## ENGINEERING CHANGE NOTICE

1 ECN 657602

13a Description of Change		13b Design Baseline Document? <input type="checkbox"/> Yes <input checked="" type="checkbox"/> No  Complete revision update of PFP Emergency Lighting Study, HNF-3178 No physical modification done to the facility, so no USQ required per PFP FSP 5-8, section 2 23		
14a Justification (mark one) Criteria Change <input type="checkbox"/> Design Improvement <input type="checkbox"/> Environmental <input type="checkbox"/> Facility Deactivation <input type="checkbox"/> As Found <input checked="" type="checkbox"/> Facilitate Const <input type="checkbox"/> Const Error/Omission <input type="checkbox"/> Design Error/Omission <input type="checkbox"/>				
14b Justification Details Backup and emergency lights in buildings 236 Z, 270 Z 2701 ZD, and 2705-Z were upgraded by ECNs 649762 and 649761 This ECN documents those changes in this document				
15 Distribution (include name MSIN and no of copies)

# PFP EMERGENCY LIGHTING STUDY

O  
2736-Z & ZB  
All  
6

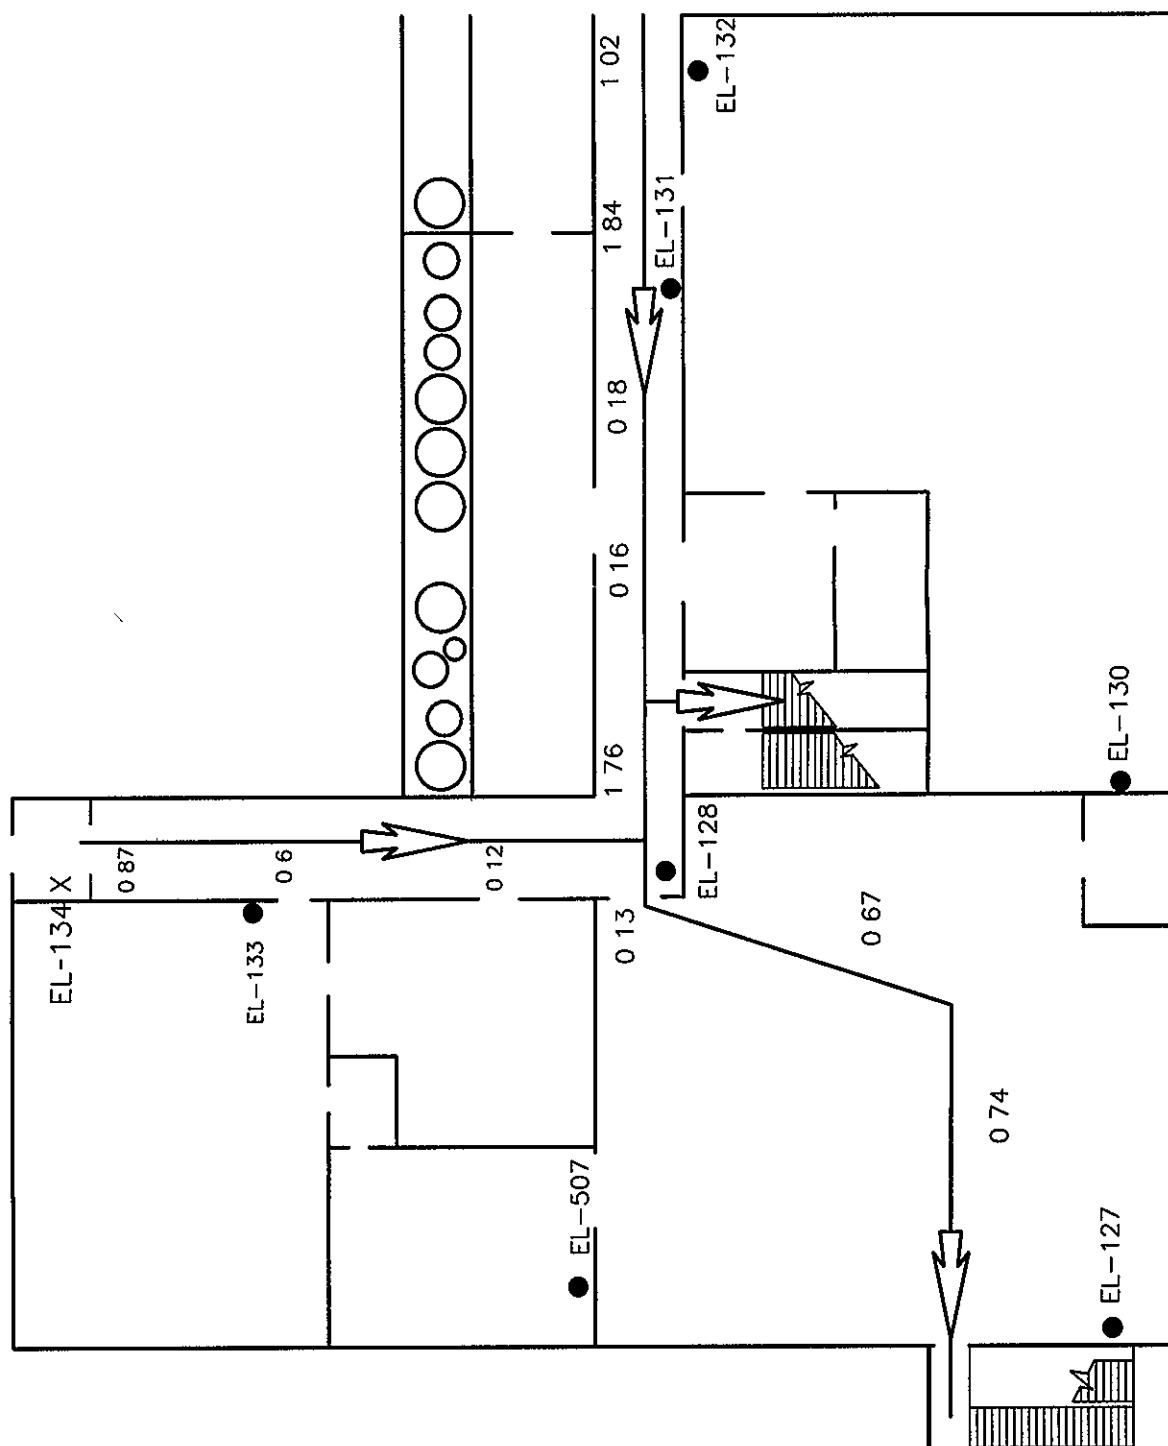
Although these buildings already have installed Emergency Lights, the lights are connected to the emergency lighting panels instead of the normal lighting panels. All lights in these buildings will be rewired to the normal lighting circuit in that area. Since the existing lights will illuminate if power is lost to the emergency panels and the existing light levels are approximately 0.5 footcandle average, this group was placed sixth on the priority list.

One new Emergency Light will be added as shown in Appendix A to correct a low intensity area in the entry corridor. For the remainder of the building, even though the current light levels do not quite meet the NFPA requirements, new Emergency Lights will not be added due to the reasonable existing coverage. Two Backup Lights will be added to the change room exits for added personnel safety during normal egress during a lighting outage. The 8 lights in the 2736-Z and ZB vaults will be removed since the vault doors remain open if people are inside. In an egress situation, illumination will be provided from the corridor Emergency Lights. This represents a significant exposure and manhour reduction.

GROUP	G
BUILDING	234-5Z
LOCATION	2nd floor east
PRIORITY	7

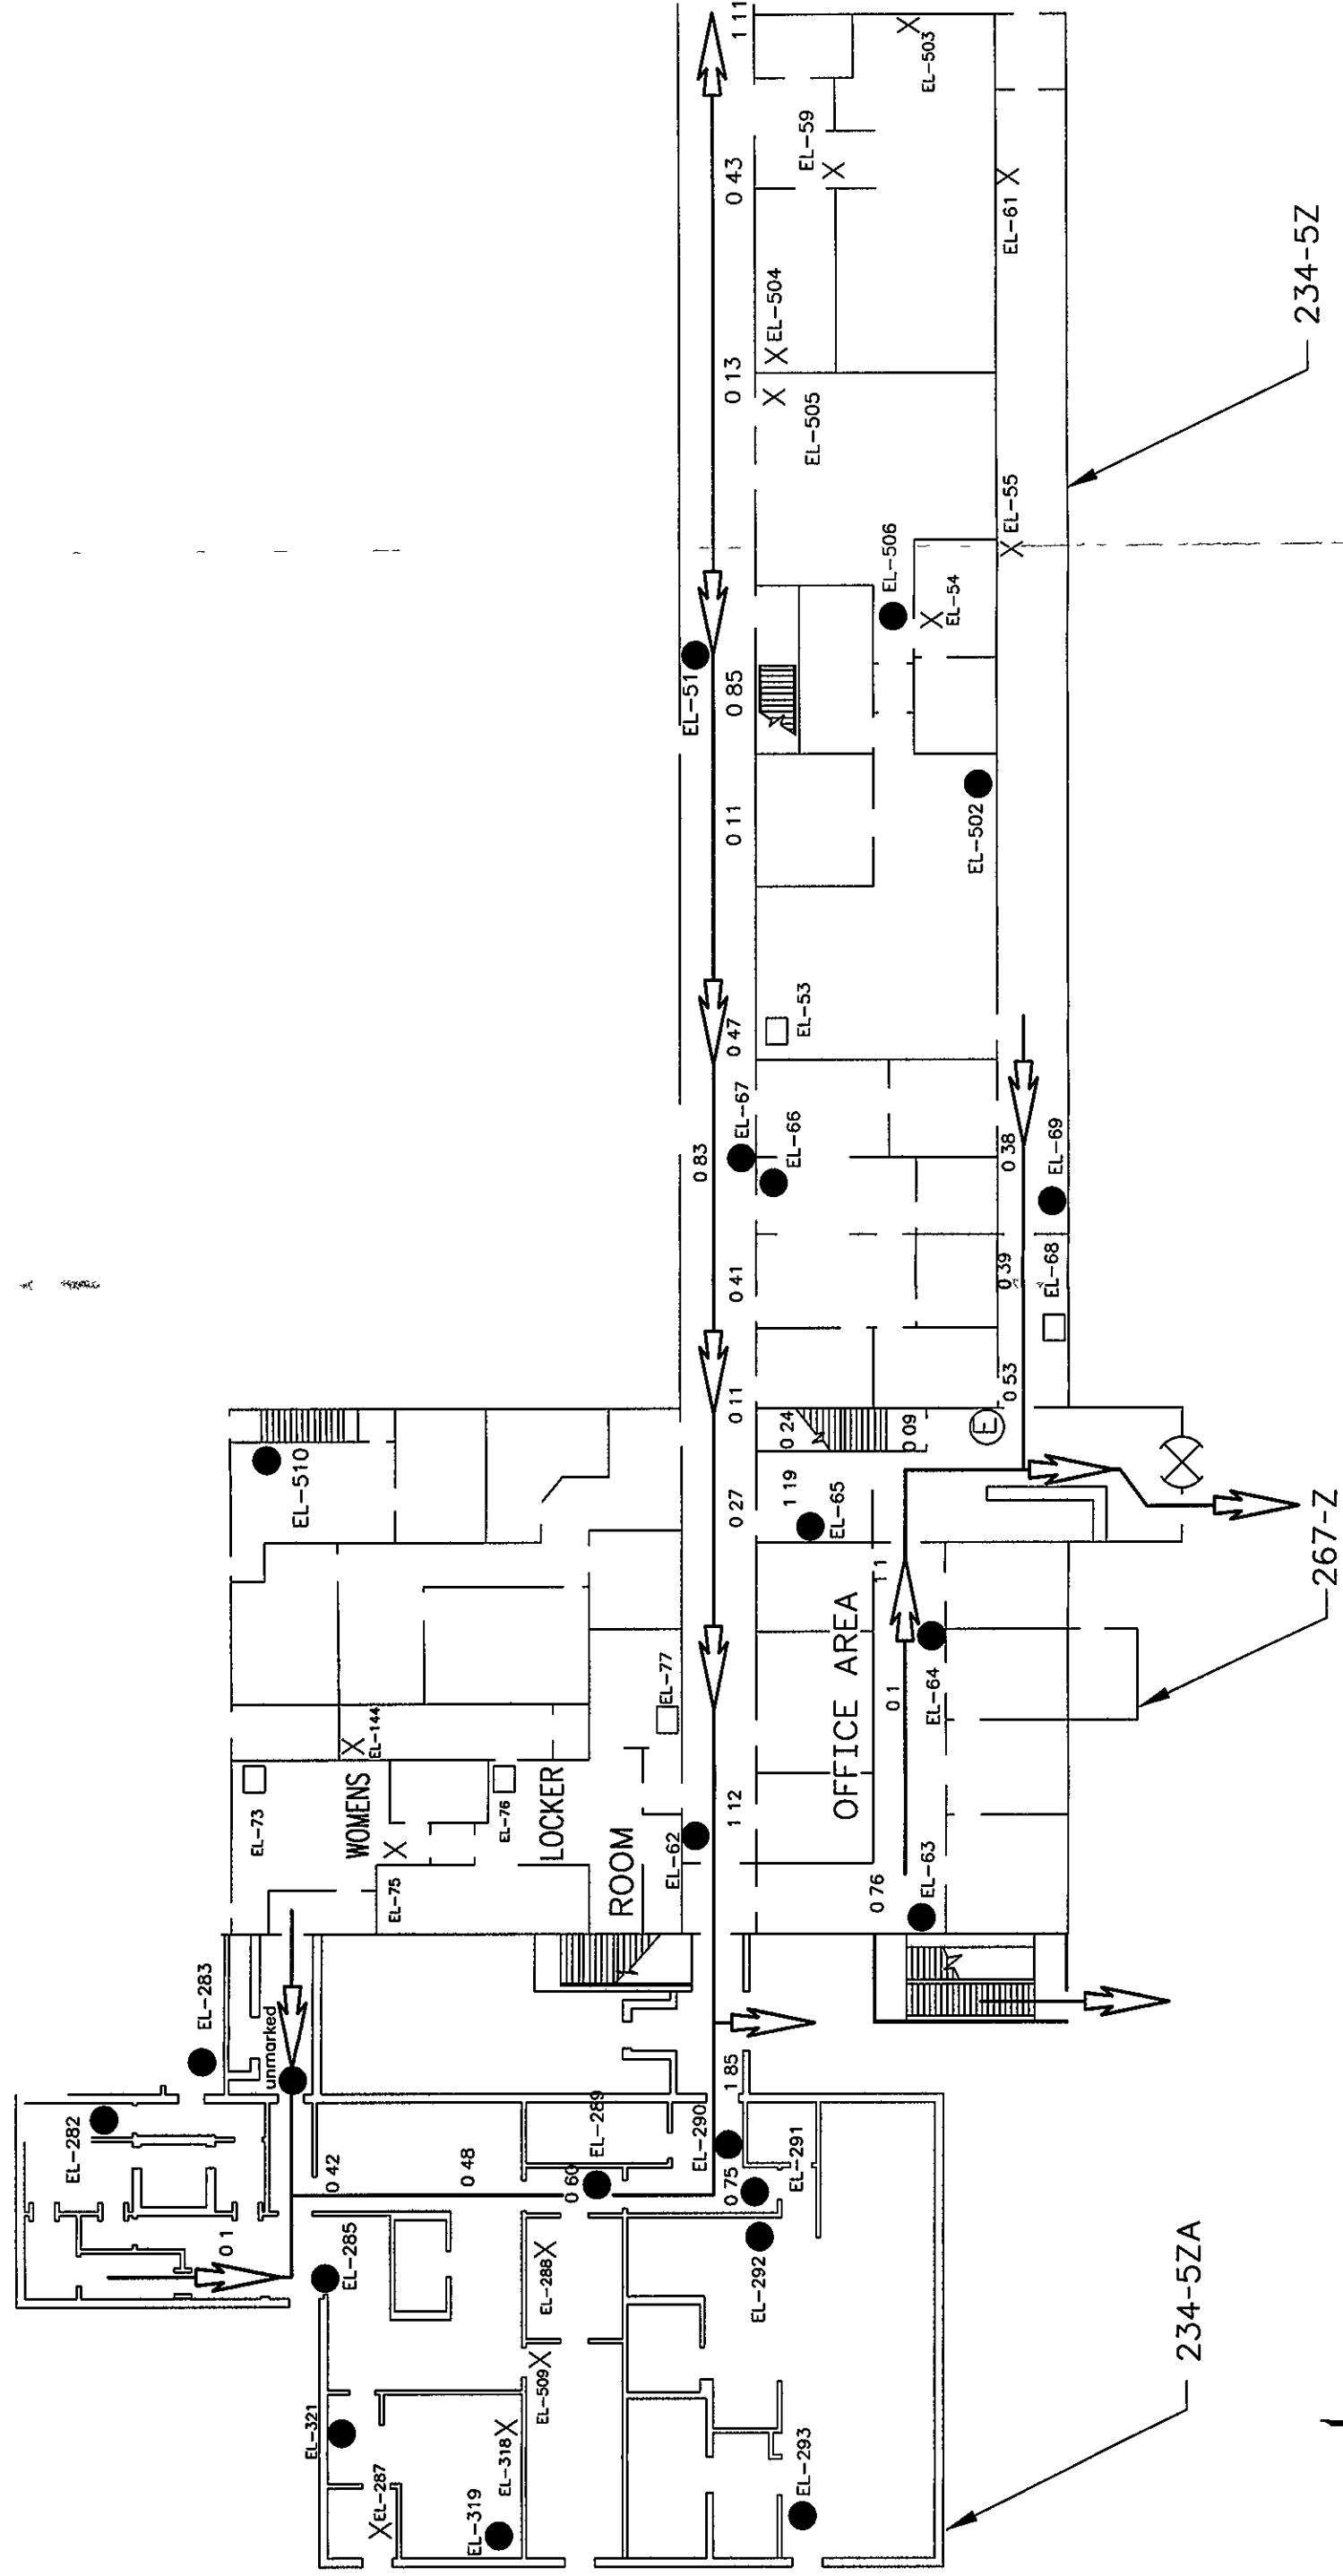
This is a standard hallway/office area with a few dark spots along the egress route. These low intensity spots below the 0.1 footcandle minimum will be upgraded with 3 additional lights as shown in Appendix A. The remainder of the egress routes will not be upgraded as explained above due to the limited life expectancy of the facility and the existing light levels. There are 2 lights to be removed and 2 lights with incorrect power sources.

GROUP	BUILDING	LOCATION	PRIORITY
A	234-5Z	Front side offices & change room	8

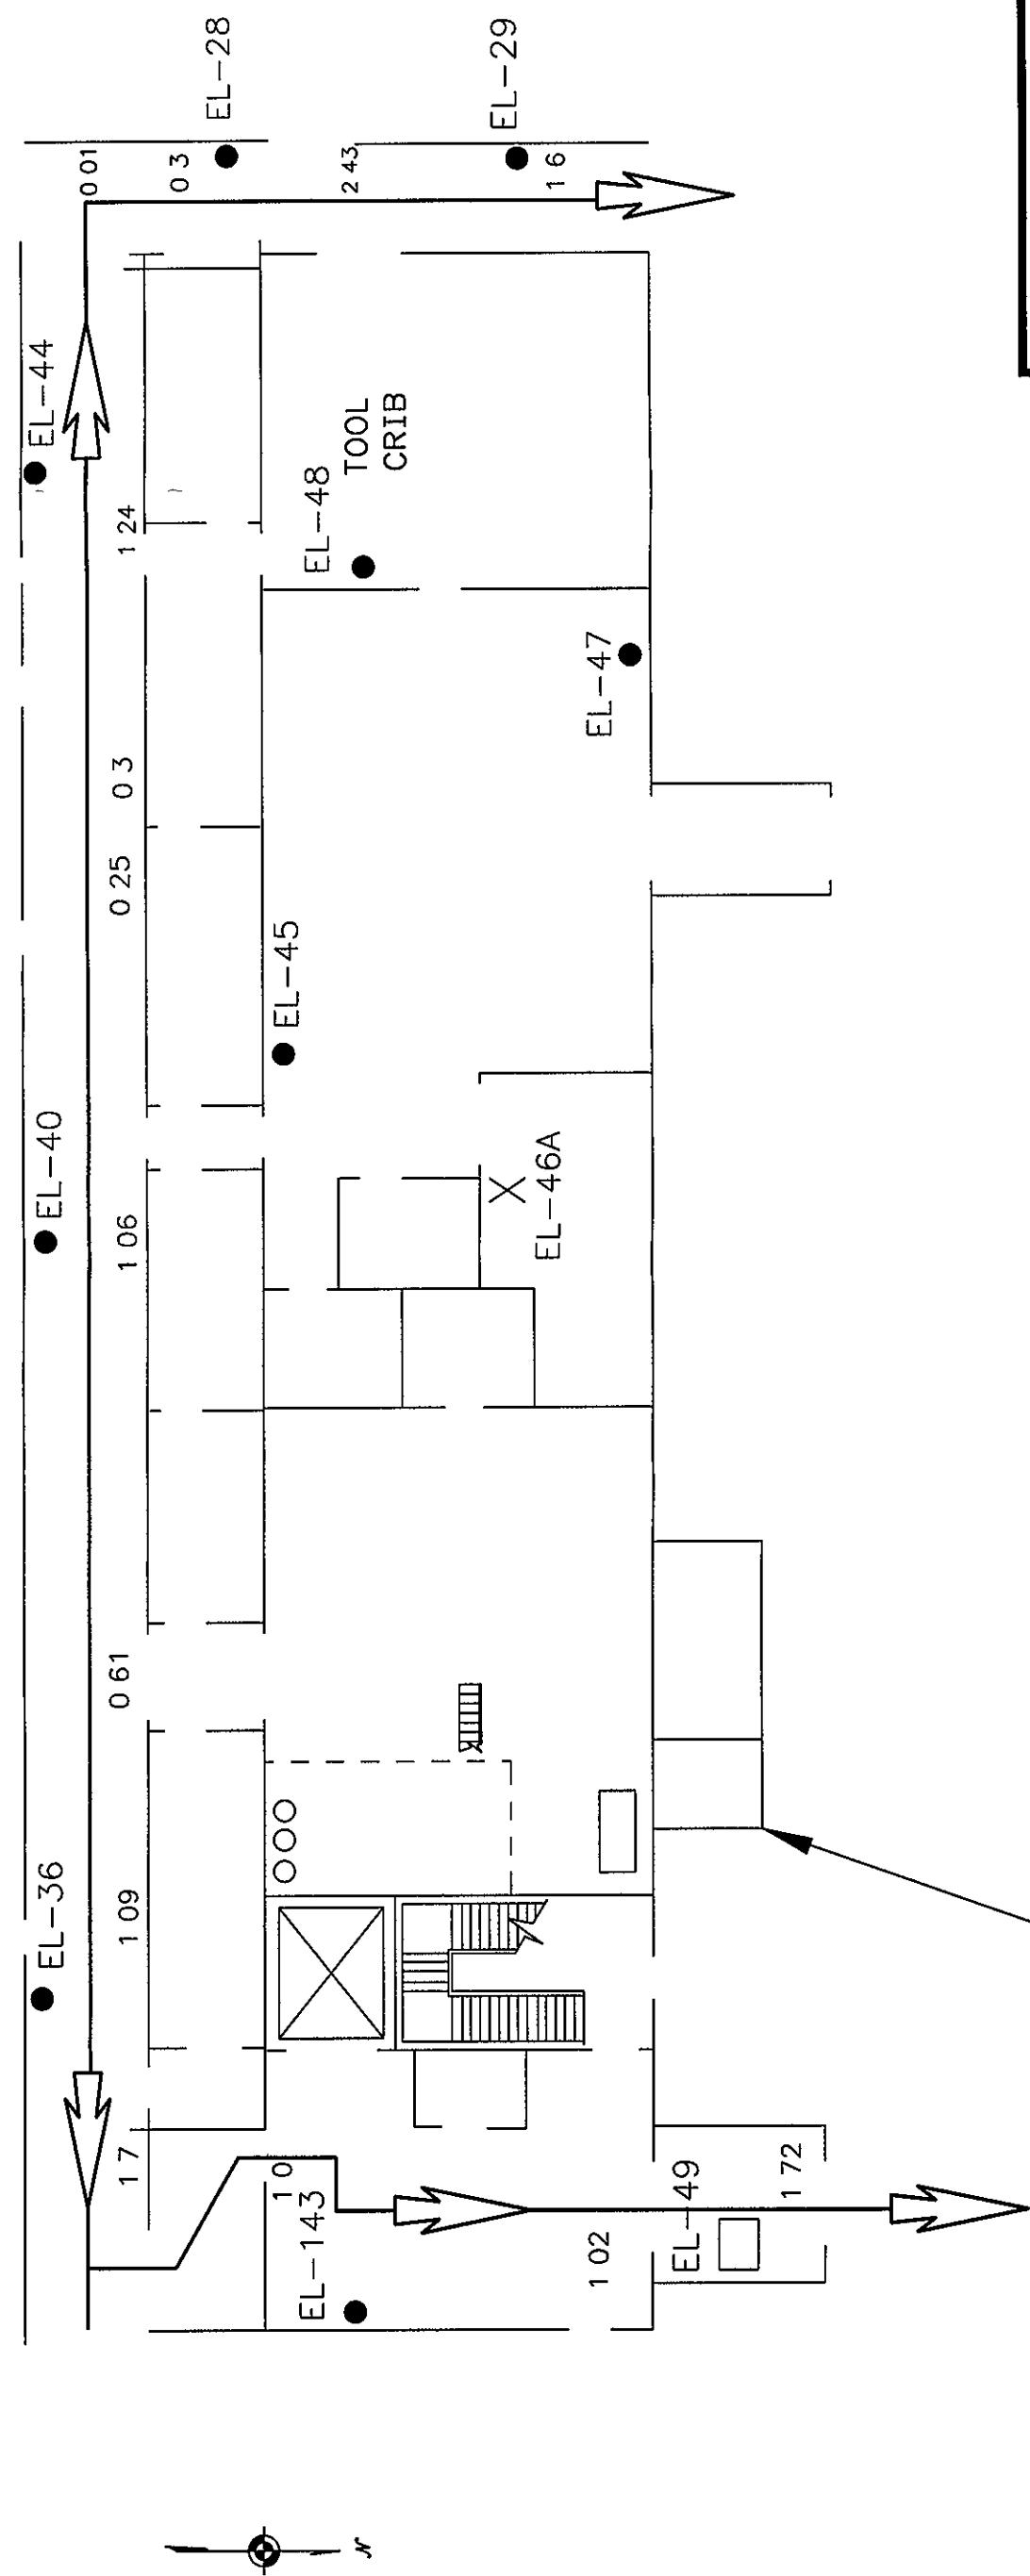
As in Groups G & H above, only the areas below 0.1 footcandle will be upgraded. This will require one light positioned as shown in Appendix A. Additionally, 13 lights will be removed, 6 lights have incorrect power sources, and 2 lights require relabeling.

- Existing lights which require no changes
- (E) Lights to be added (1)
- ×
- Emergency lights with wrong power sources (5)
- Note: Numbers along egress routes are light level measurements taken under WP 95-959

GROUP	B
BUILDING	234-5Z
LOCATION	Maintenance area
PRIORITY	9

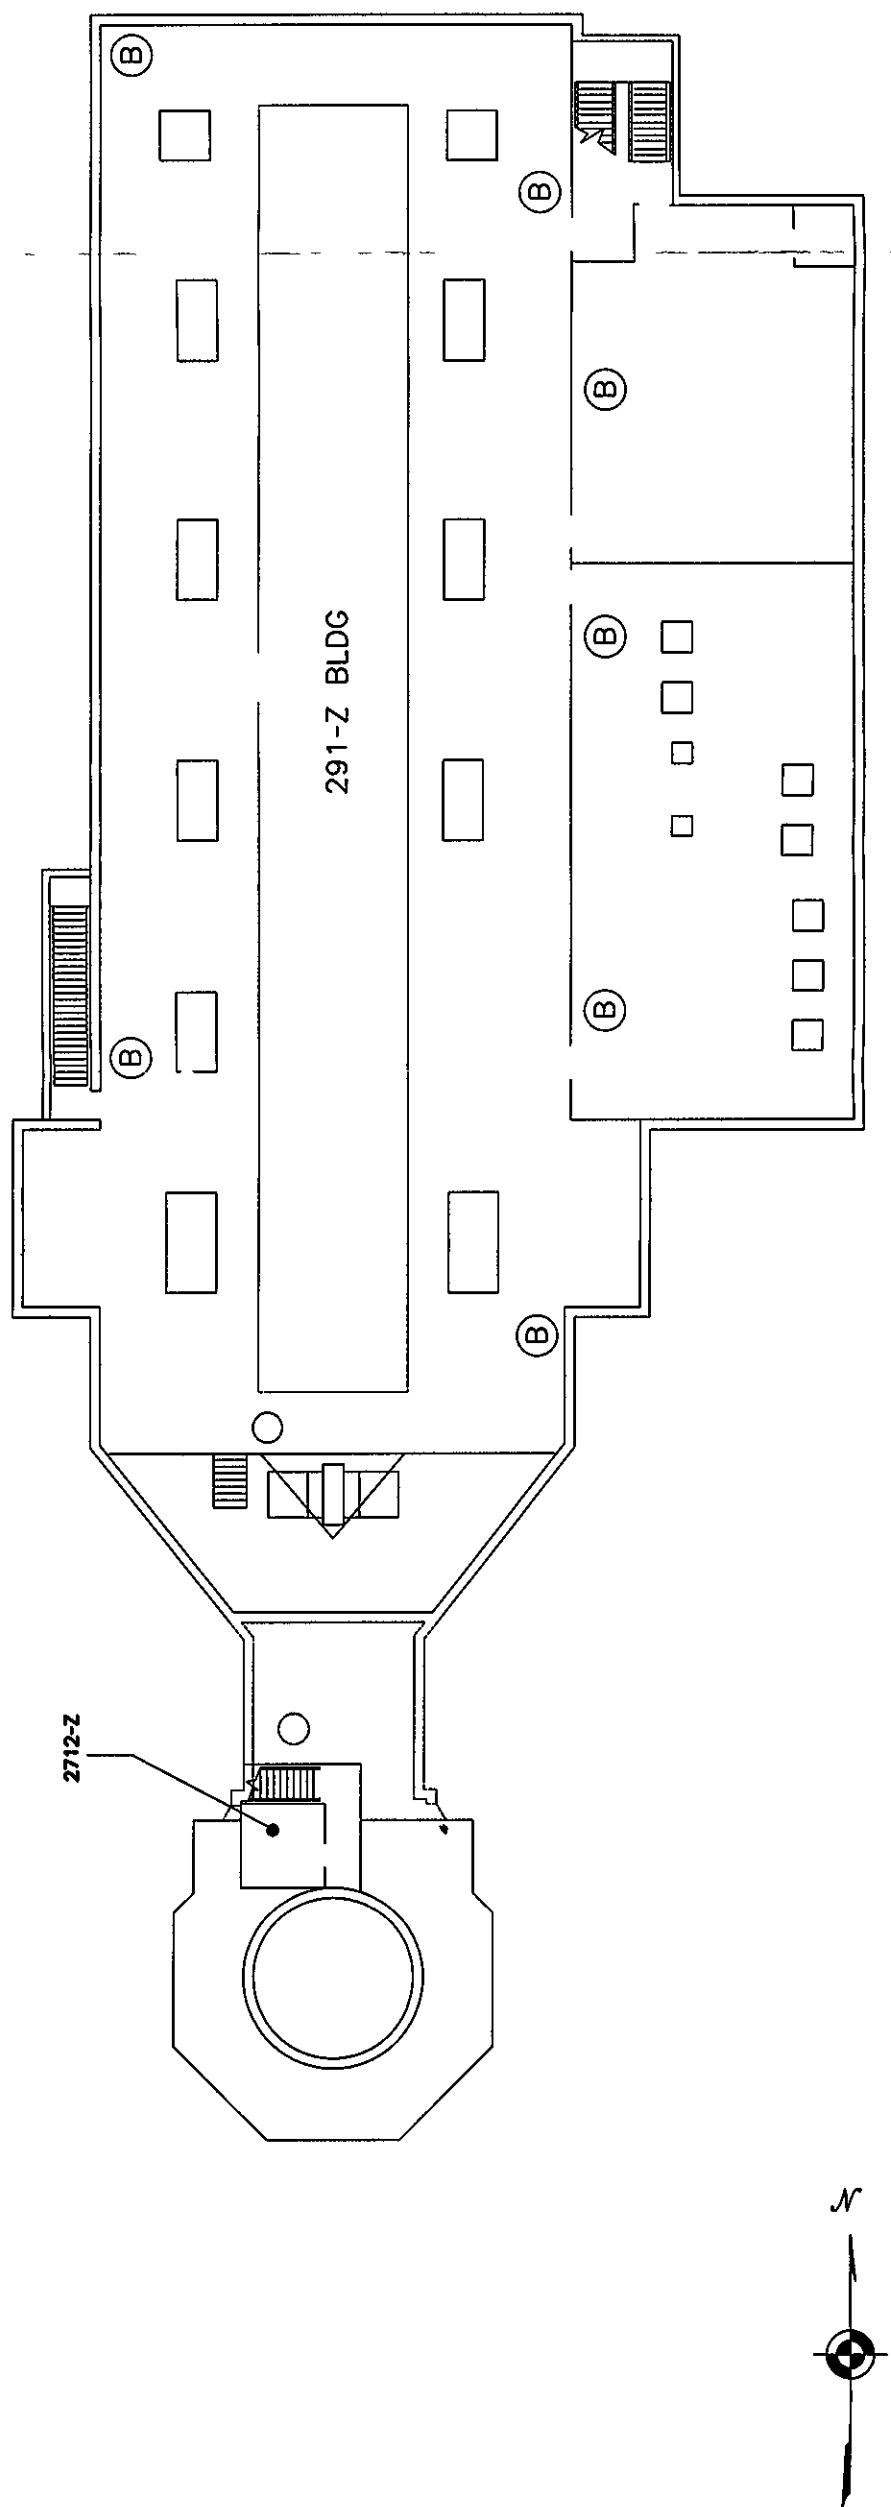
No upgrade will be made to this group since there are no areas below the 0.1 footcandle minimum. There is, however, one light to be removed and one light on an incorrect power source.

- Existing lights which require no changes
- ✗ Lights to be removed (1)
- Emergency lights with wrong power sources (1)
- Note Numbers along egress routes are light level measurements taken under WP 95-959
